**FINDINGS AND RECOMMENDATION  
OFFICE OF PLANNING AND ZONING  
ANNE ARUNDEL COUNTY, MARYLAND**

**CASE NUMBER:** 2024-0222-V

**REQUEST**

The applicants are requesting a variance to allow an accessory structure (freestanding deck) with lot coverage nearer to the shoreline than the existing principal structure on slopes greater than 15% and with less setbacks than required on property located at 942 Long Cove Road in Glen Burnie.

Proposed 10x30  
open deck

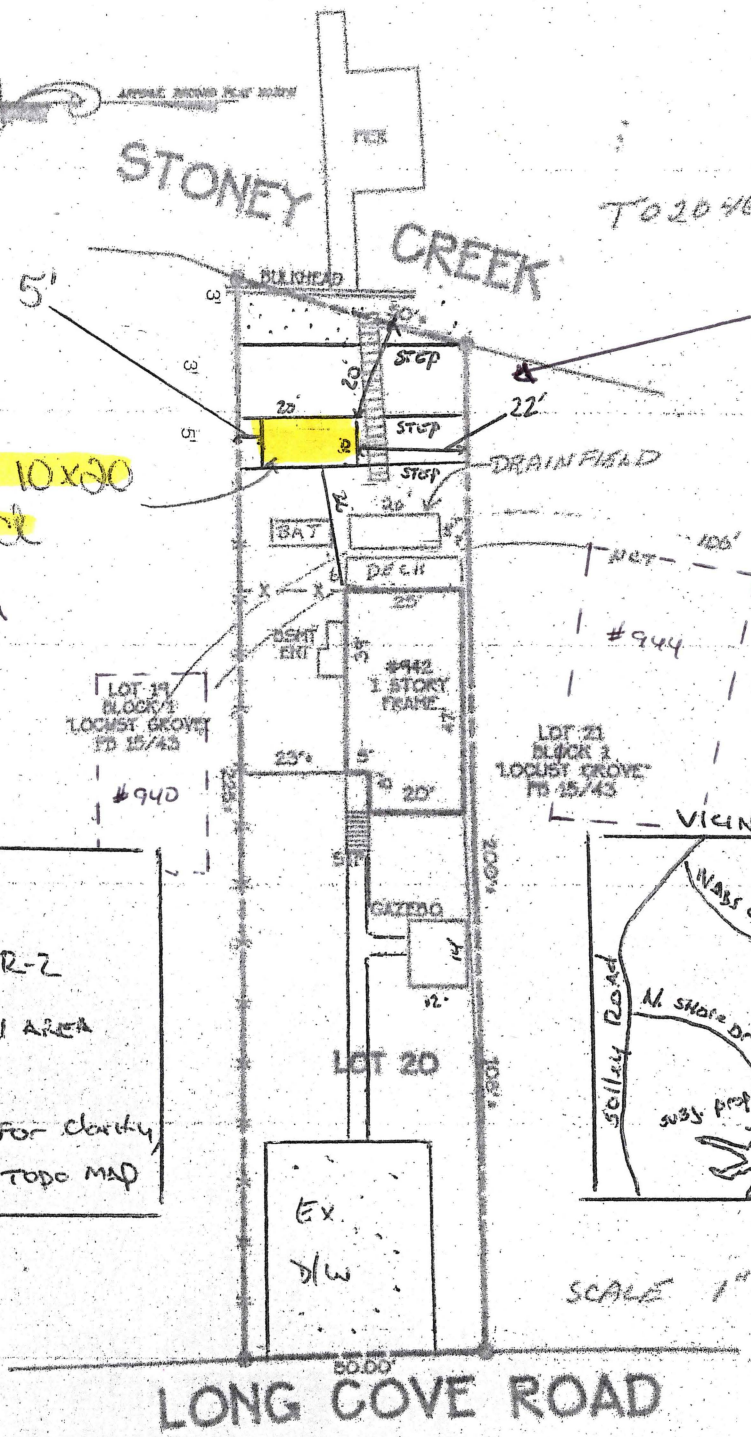
§ 18-4-601 of the Anne Arundel County Zoning Ordinance provides that the minimum setbacks for accessory structures in an R2 District is 40 feet from the front lot line<sup>1</sup>, and 7 feet from the side lot lines<sup>2</sup>. The deck will be as close as 20 feet from the mean high water line, and 5 feet from the side lot line, necessitating variances of 20 feet and 2 feet, respectively.

§ 17-8-702(b)(1) provides that, in a BMA - Buffer Modification Area, no new lot coverage shall be placed nearer to the shoreline than the closest facade of the existing principal structure. The detached deck will create 200 square feet of new lot coverage<sup>3</sup> nearer to the shoreline than the principal structure, necessitating a variance.

§ 17-8-201(a) provides that development in the limited development area (LDA) may not occur within slopes of 15% or greater unless development will facilitate stabilization of the slope; is to allow connection to a public utility; or is to provide direct access to the shoreline; and, all disturbance shall be limited to the minimum necessary. The detached deck will disturb slopes of 15% or greater, necessitating a variance. The final amount of disturbance will be determined during permit review.

The subject property is rectangular in shape and is undersized for lots in an R2 District at 10,824 square feet in area and 50 feet in width, with regard to the 20,000 square foot minimum area required for new lots not served by public sewer, and to the minimum width of 80 feet. The property is encumbered by steep slopes<sup>4</sup> along the waterfront which has been developed with tiered retaining walls. The site plan shows a deck running the width of the waterfront facade of the dwelling, however, aerials show only steps to grade from the center sliding glass door.

The existing critical area lot coverage<sup>5</sup> shown on the site plan is 3,109 square feet. The proposed post-construction lot coverage is 3,309 square feet, which is below the lot coverage allowed under §17-8-402 (31.25%, or 3,382.5 square feet). The existing coverage by structures shown on the site plan is 1,343 square feet. The proposed post-construction coverage by structures is 1,543 square feet, which is below the 30% (3,247.2 square feet) maximum coverage by structures allowed under § 18-4-601. However, these coverage amounts may not be accurate as there appears to be gravel and an unpermitted shed along the shoreline that have not been accounted for on the site plan or in the tabulations.

<sup>5</sup> The lot coverage totals don't correspond between the site plan tabulations and the Critical Area Project Notification Form. It appears the math is incorrect on the site plan.

- ***denial*** of a zoning variance to § 18-4-601 to allow an accessory structure as close as 20 feet from the front lot line and as close as 5 feet from the side lot line,
- ***denial*** of a Critical Area variance to § 17-8-702(b)(1) to allow new lot coverage nearer to the shoreline than the principal structure, and
- ***denial*** of a Critical Area variance to § 17-8-201(a) to allow disturbance within slopes of 15% or greater in the LDA.
